FINAL ISTT DESIGN

ADDENDUM

IN-SITU THERMAL TREATMENT
FRONTIER FERTILIZER NPL SITE
Davis, CA
Submittal #0012
Final RAMP
Specification 01400, Paragraph 1.5

FINAL DESIGN REPORT
ADDENDUM
IN-SITU THERMAL TREATMENT
FRONTIER FERTILIZER NPL SITE
Davis, CA

Figure# 3E

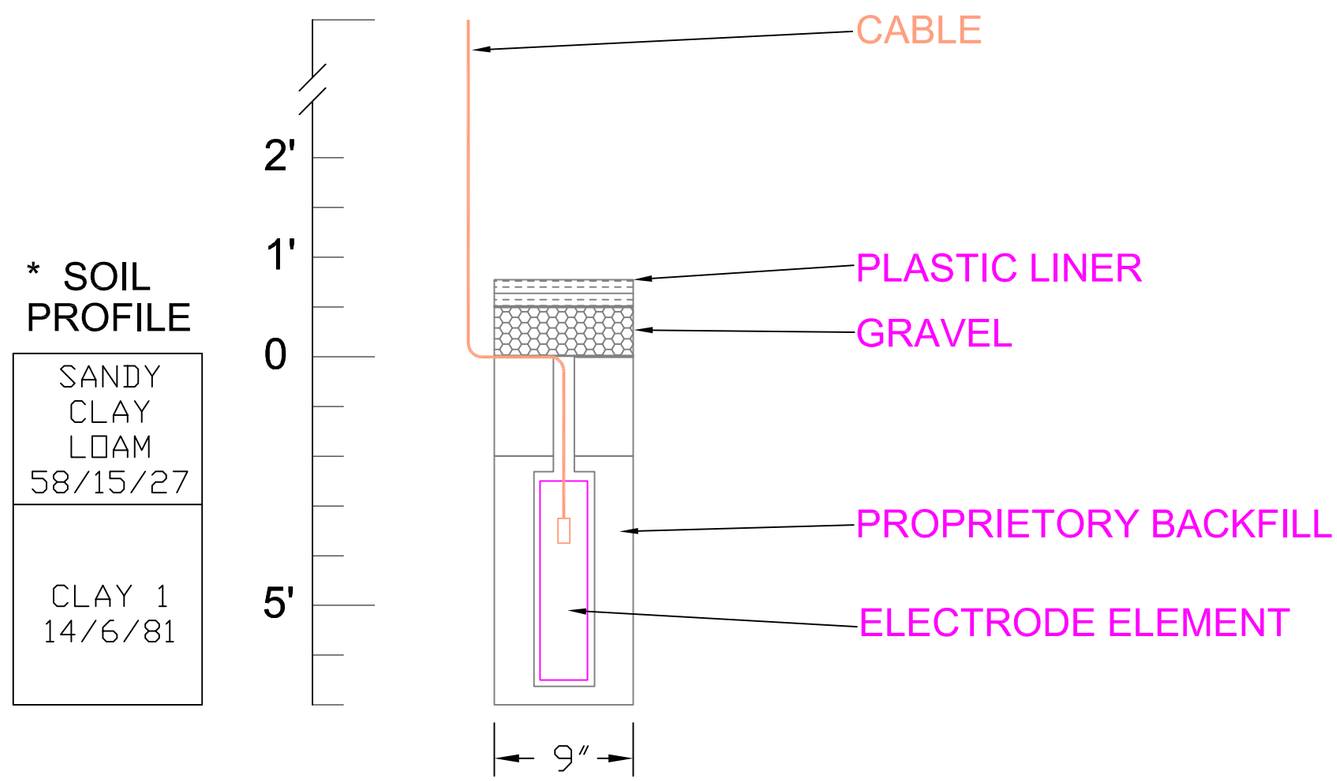
1. Electrodes/DVE wells (111). There is no change to the description or function of the main 111 electrodes that were the basis of the 1MW/ six campaign design. However, shallow ("Puppy/Cap") electrodes were added to the field installation plan to more aggressively heat the vadose zone and achieve soil temperatures of 90 +/- 10C. To this extent, 125 shallow electrodes were installed in December 2009 from 2-7 feet bgs in selected areas of Zones 1 & 2. Figure 3E shows this "Cap" electrode design and Figure 5 shows the layout of all the electrodes as constructed.

Figure# 5

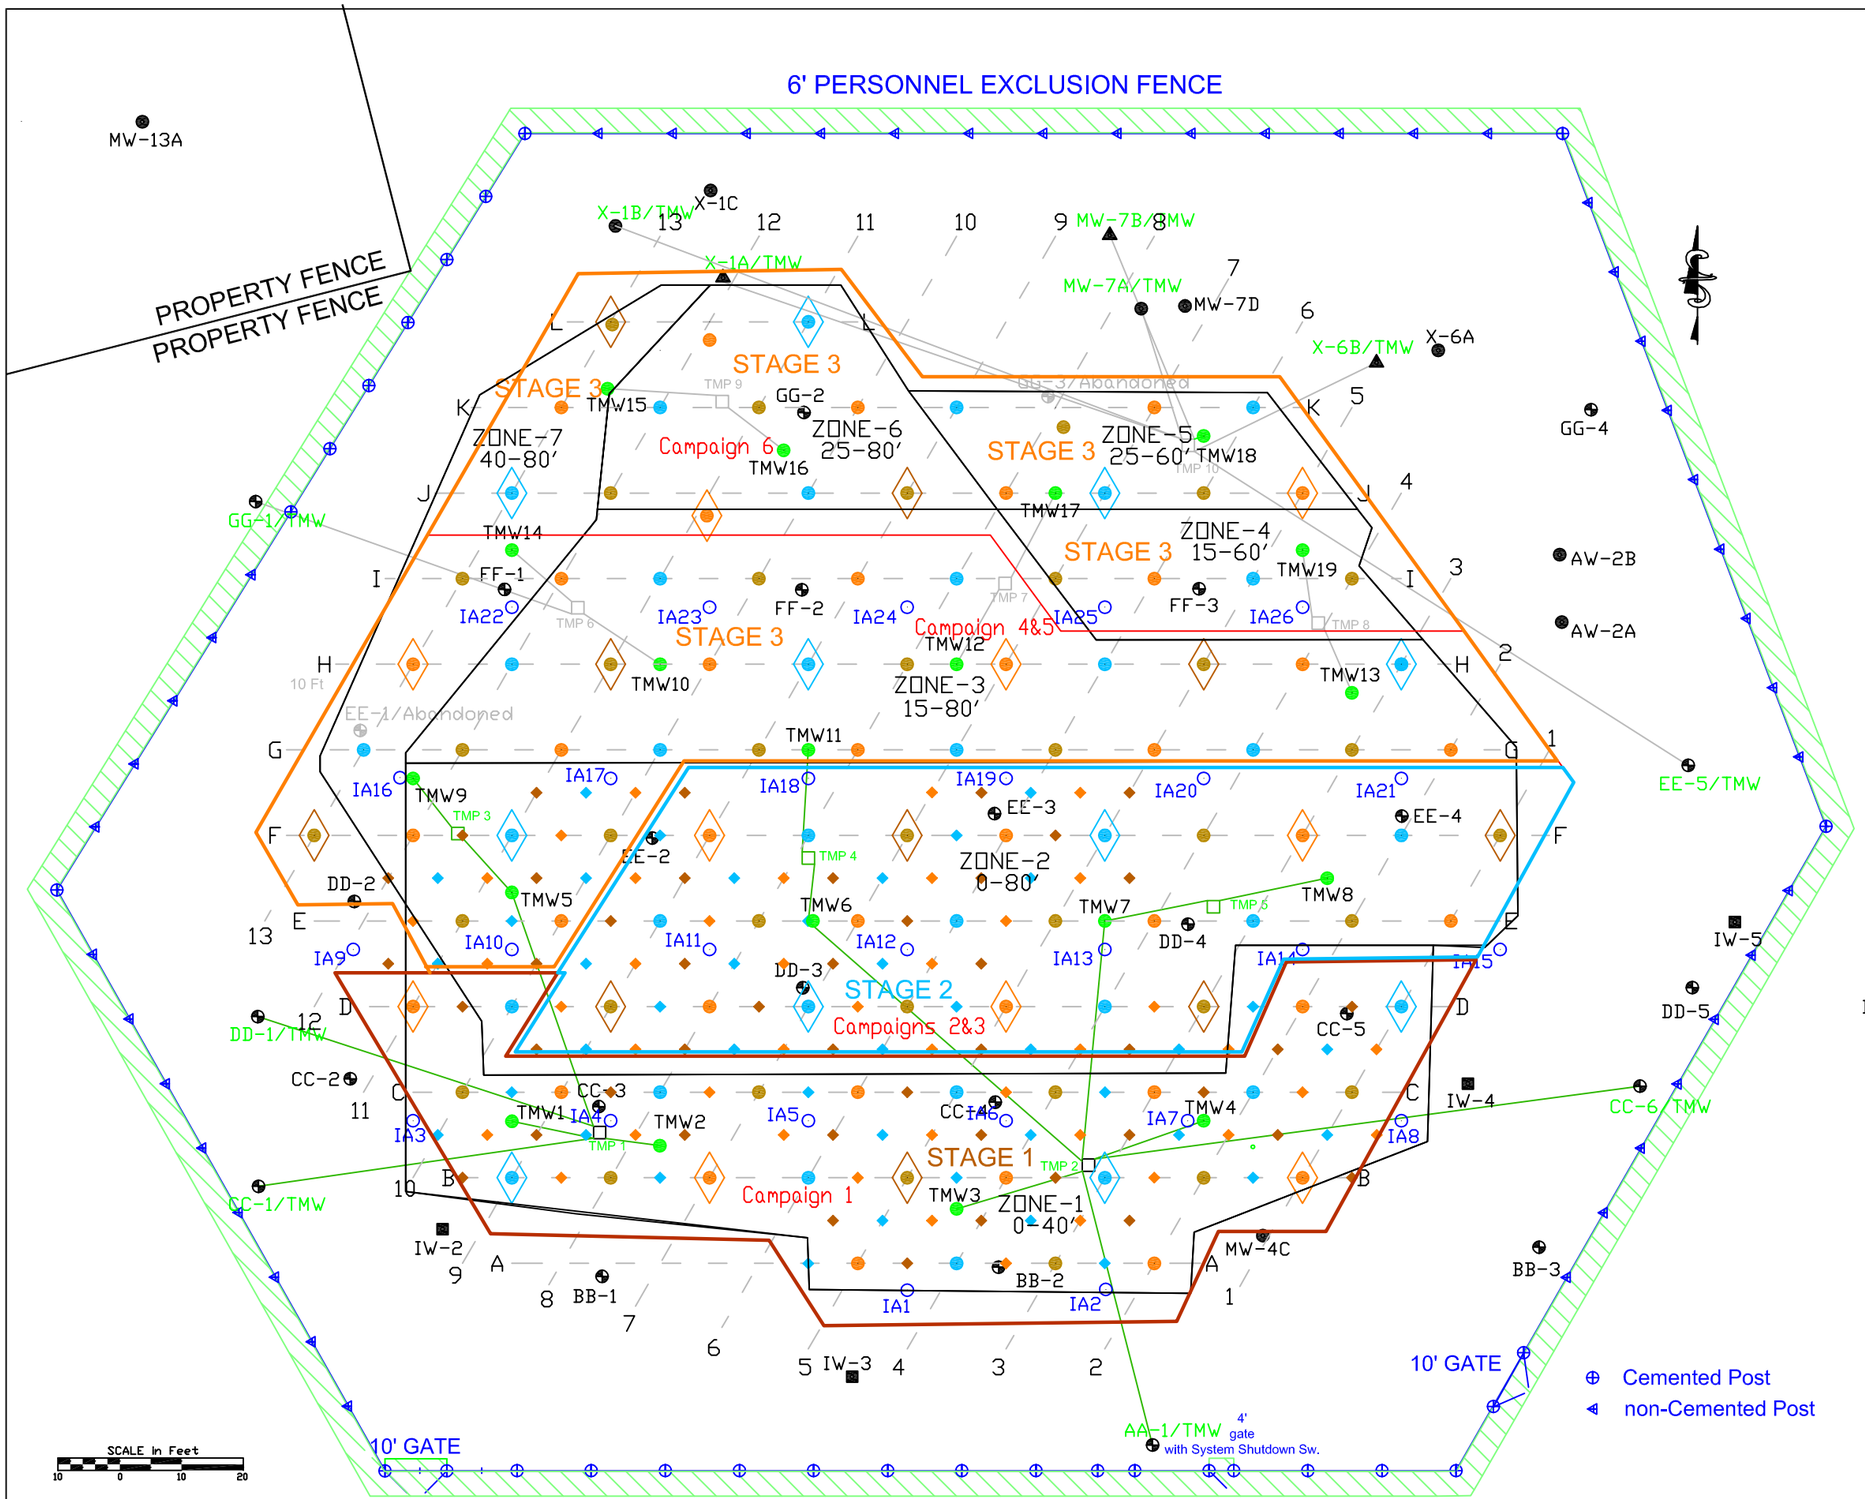
Hydraulic control will be monitored by monitoring the temperature of groundwater near but outside the treatment volume. If warmer water is not moving out from the treatment volume, then groundwater temperature will not rapidly increase outside of the treatment volume, but may show a very slow, steady increase due to heat conduction. Thermocouples have been installed in the perimeter wells and pumping wells as shown in Figure 5.

Figure# 8A

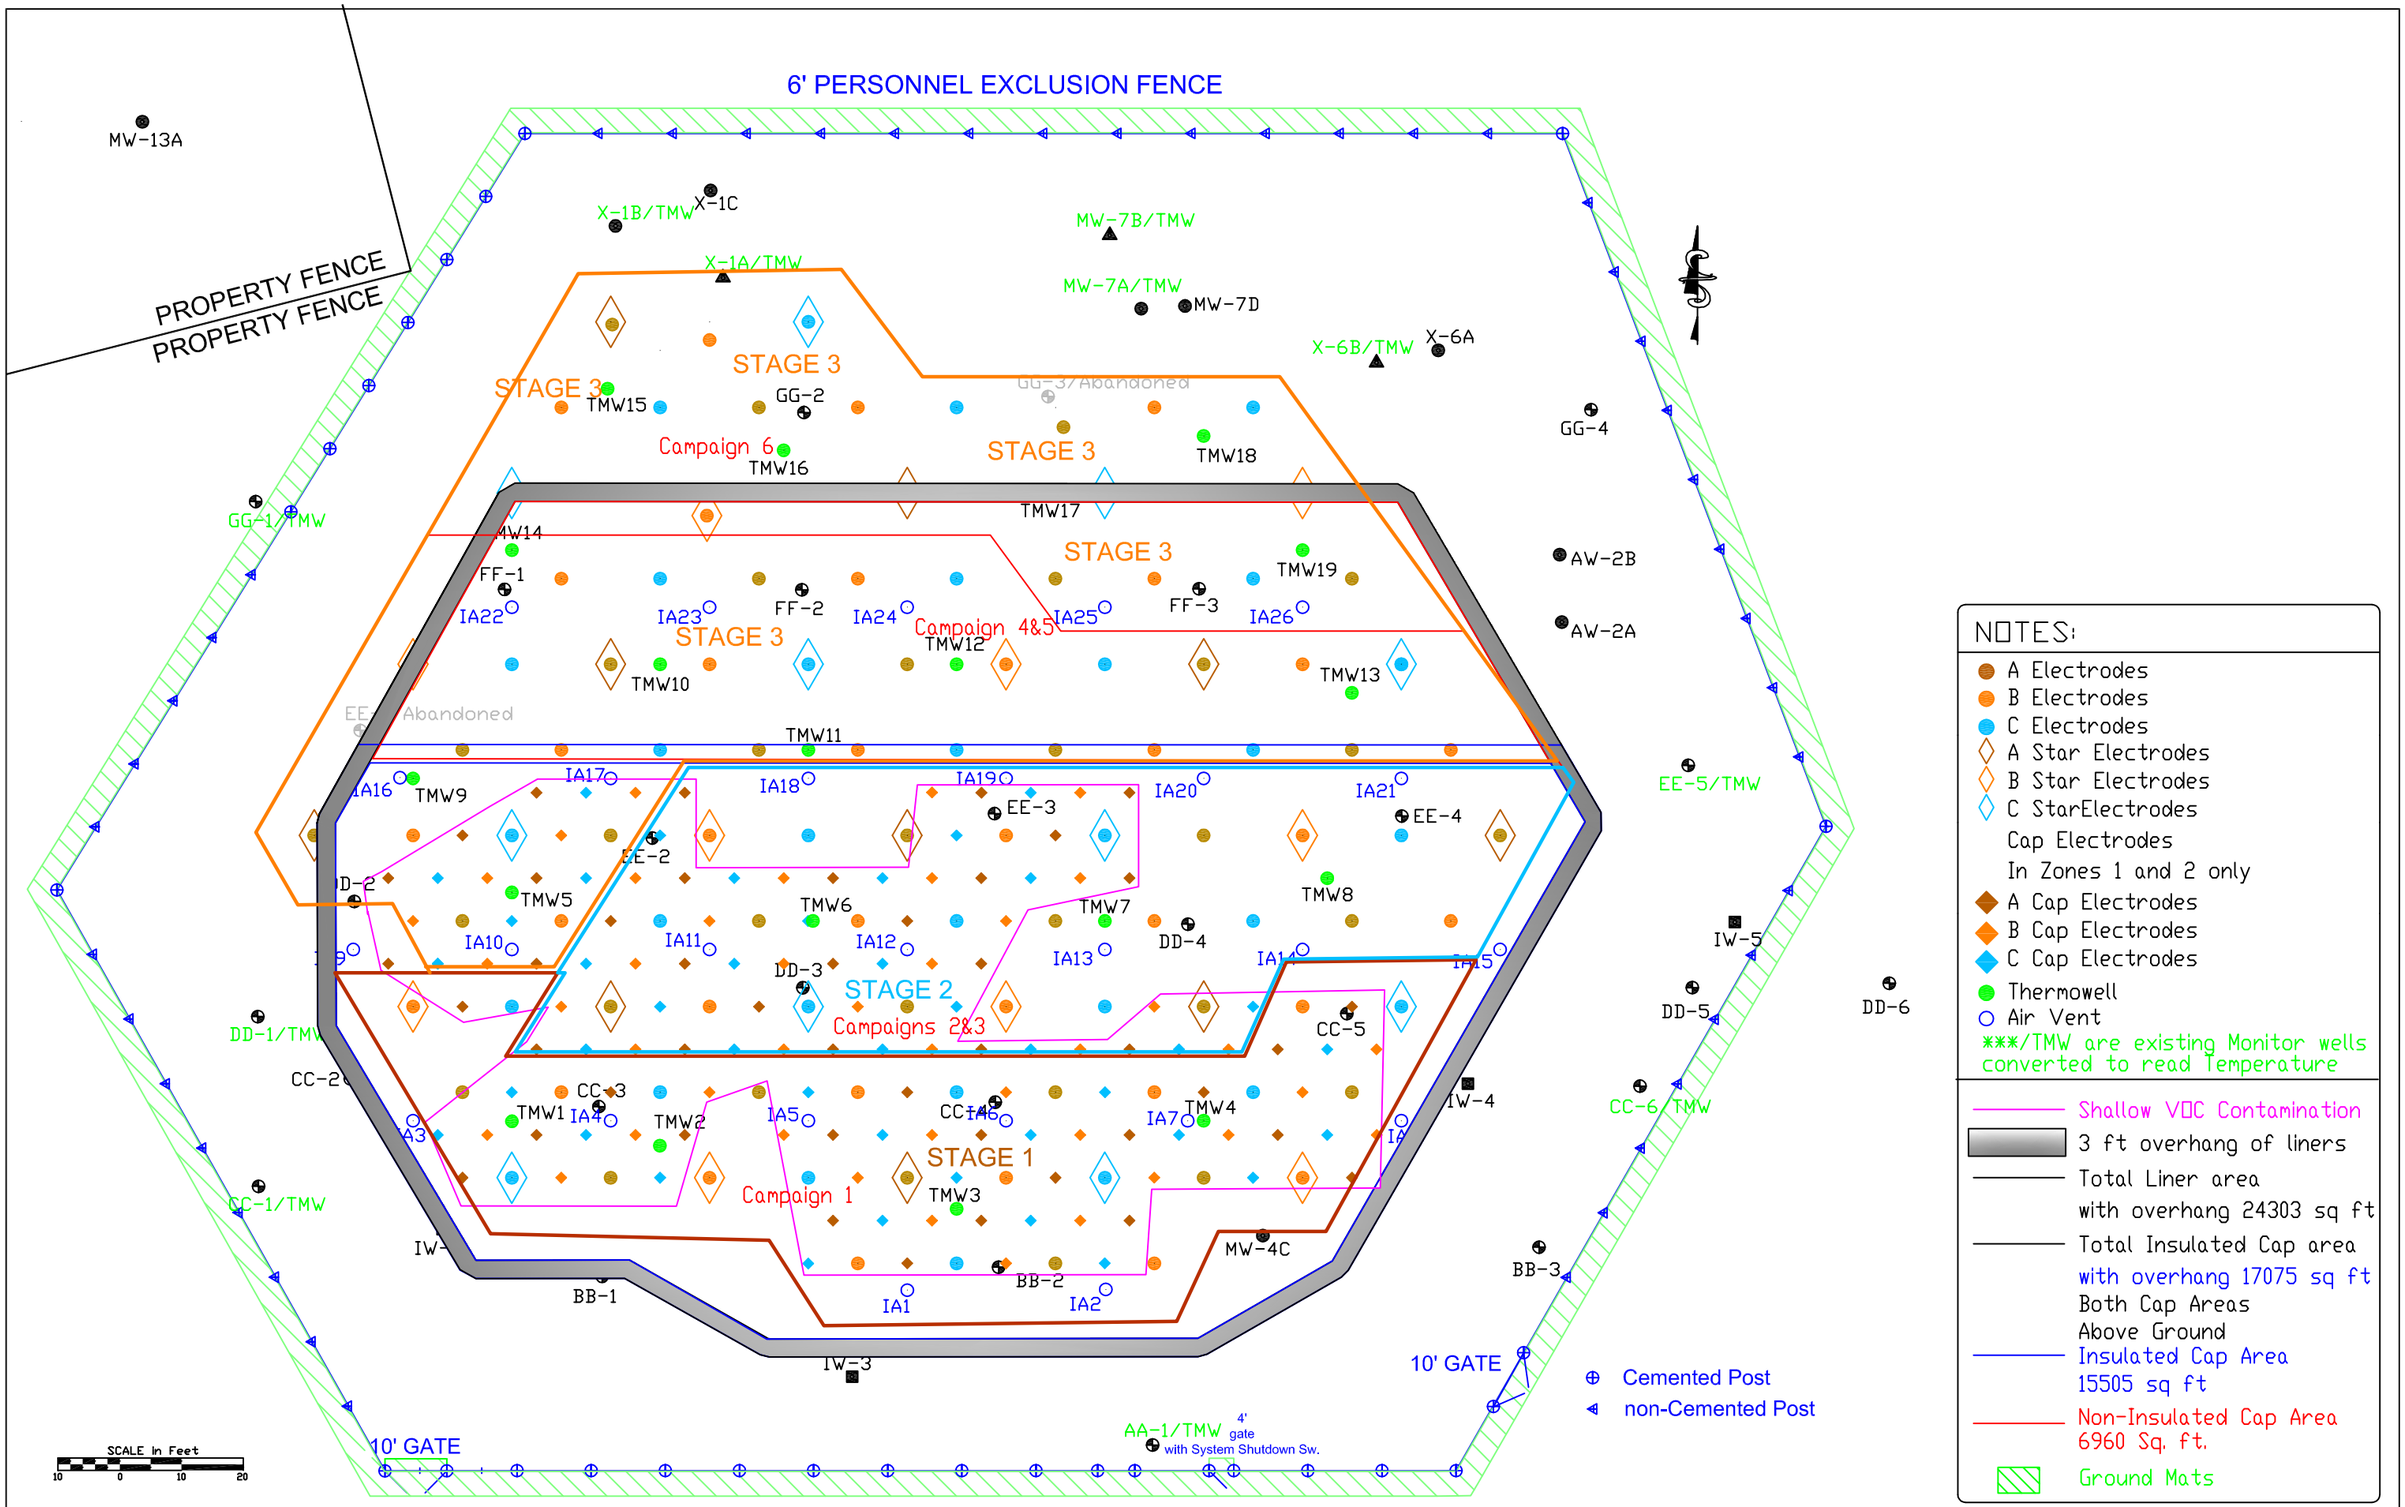
17. Site Cap. The majority of Zones 1 and 2 indicate shallow (<10ft) soil contamination that will need to remain adequately heated to carry contaminants into the cap for capture. This area will be insulated above the gravel and plastic liner and covered with another liner to reduce heat losses in this area. Figure 8A shows the layout of the cap, including the areas that are insulated and Figure 8B shows the construction details of the cap.

Figure# 9A

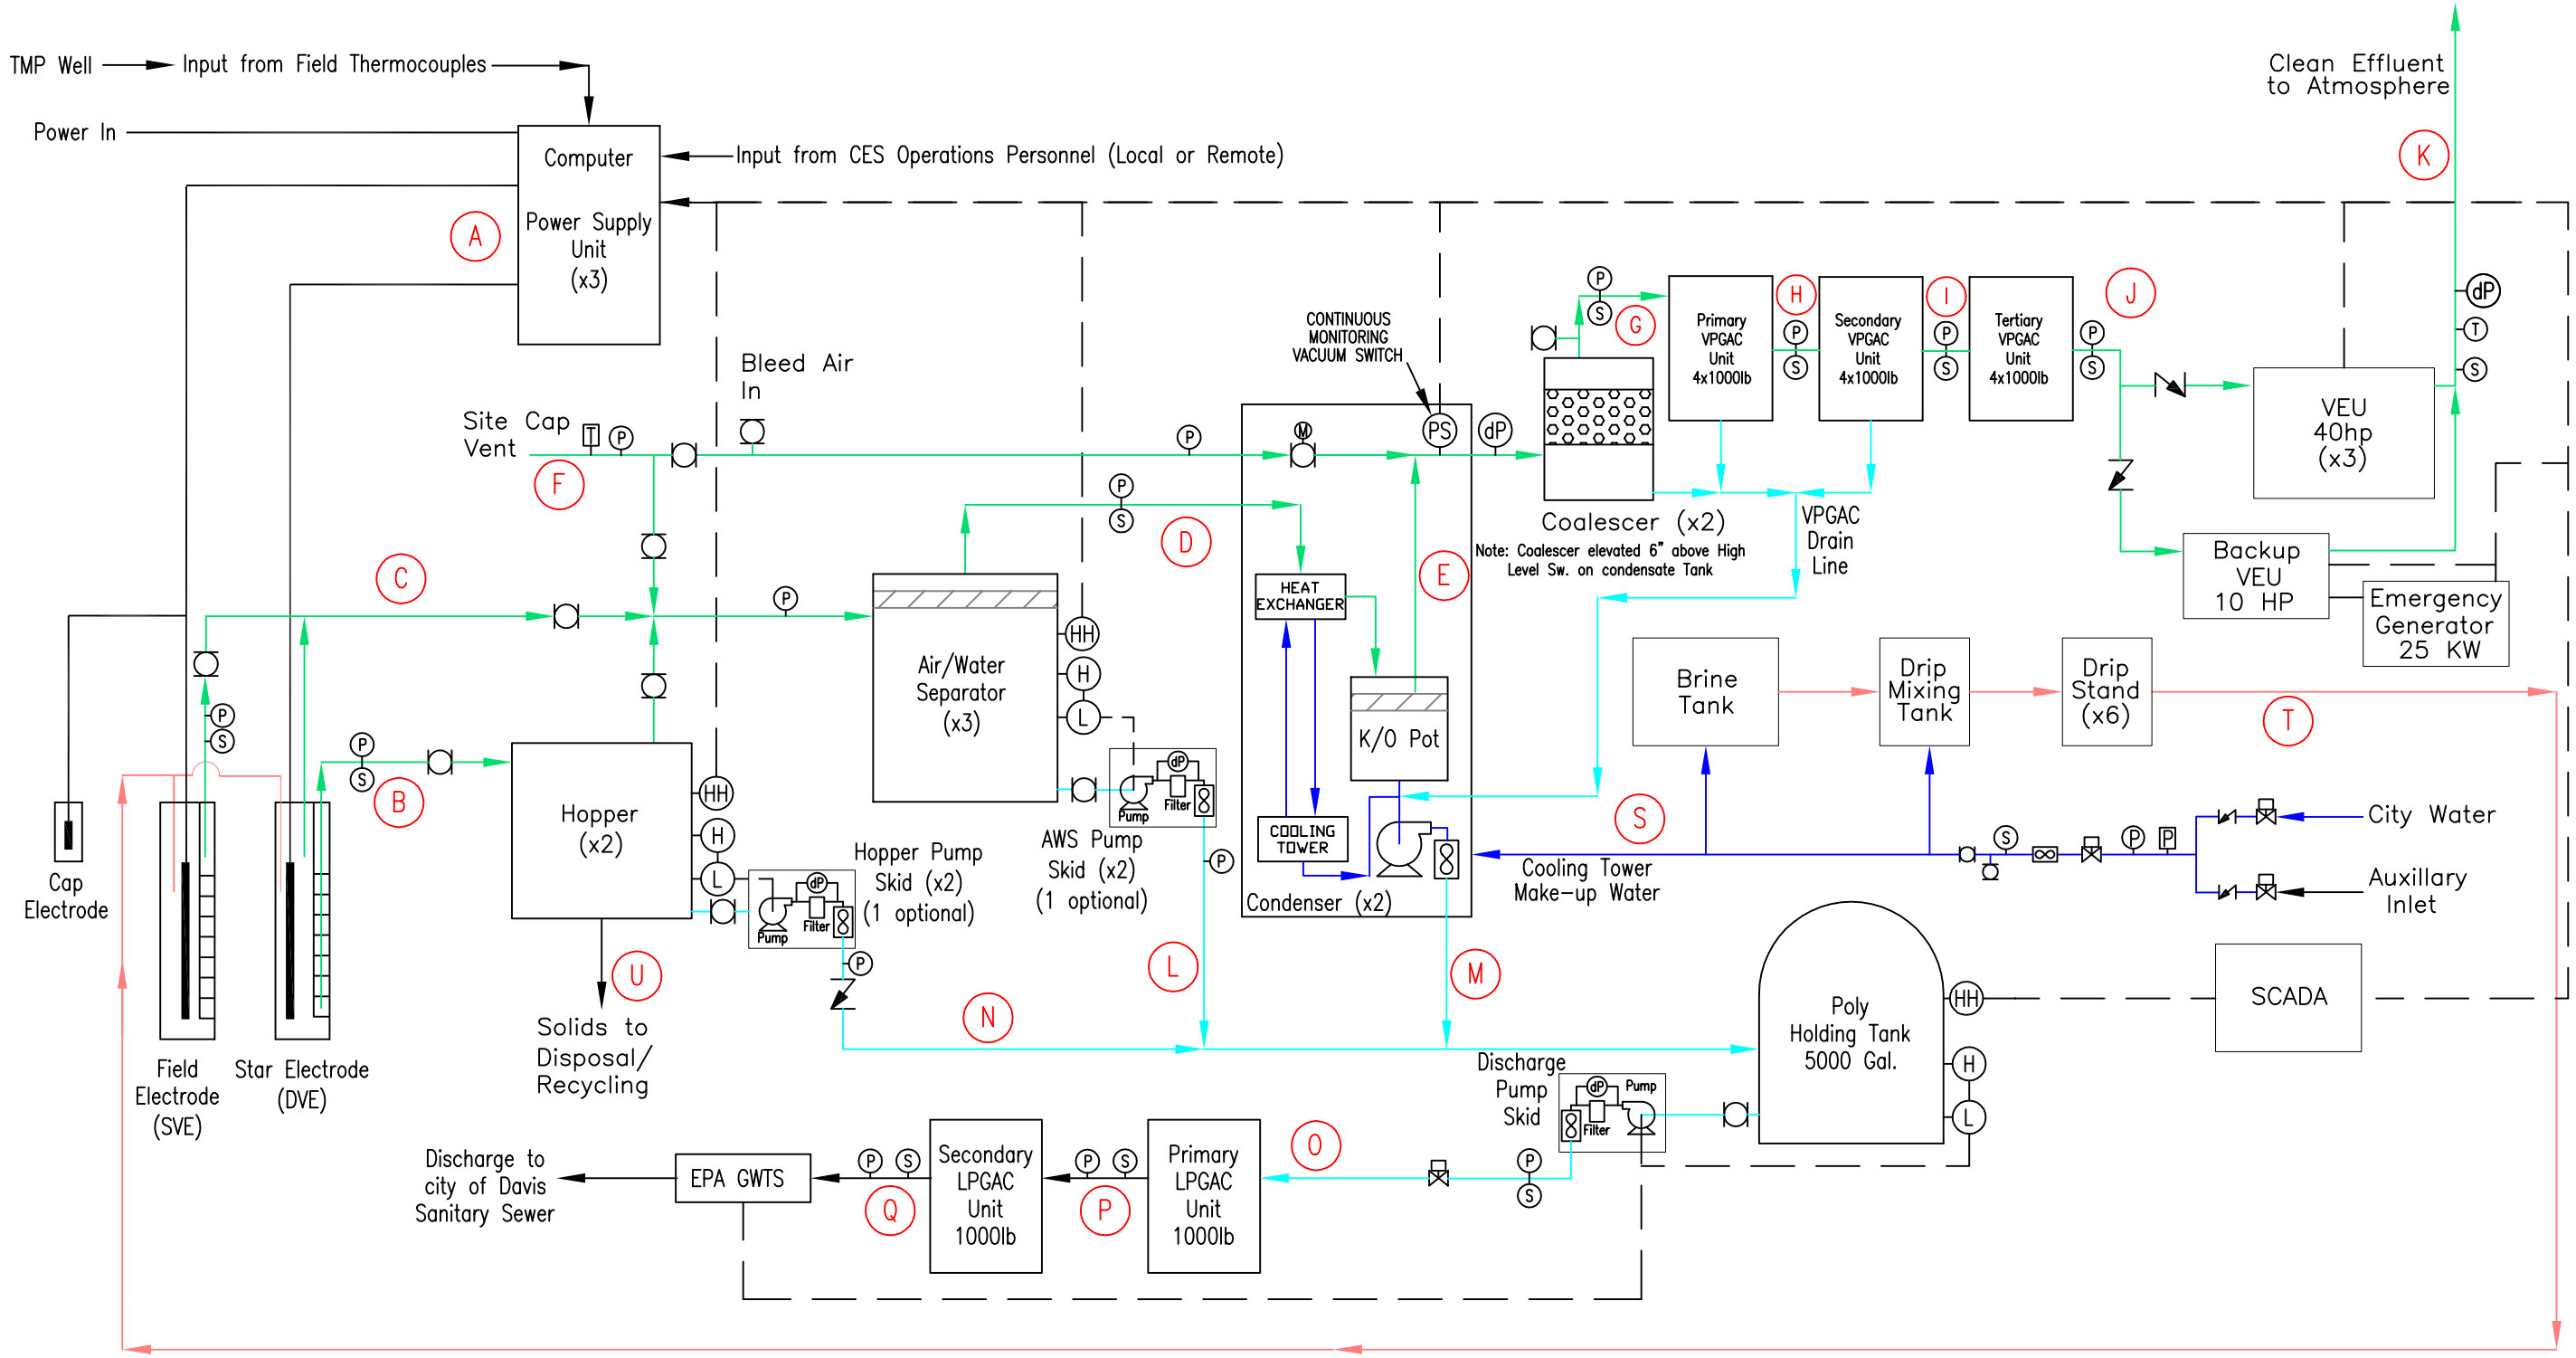
These components collectively comprise the ISTT system and are shown on a process and instrumentation diagram (P&ID) in Figure 9. Note that Figure 9 shows the process flow for the anticipated two ERH equipment setup systems, while Figure 9B shows the layout of the equipment, including the potential backup setups where appropriate.

Figure 9 (P&ID) contains the interlock control function of the ISTT process components. Interlock controls are designed to operate or shut-down system components. Sensors which do not have control functions are for monitoring and recording purposes only. The data recorded by these sensors will be collected (typically hourly) by the SCADA system and recorded in the ISTT process data log.
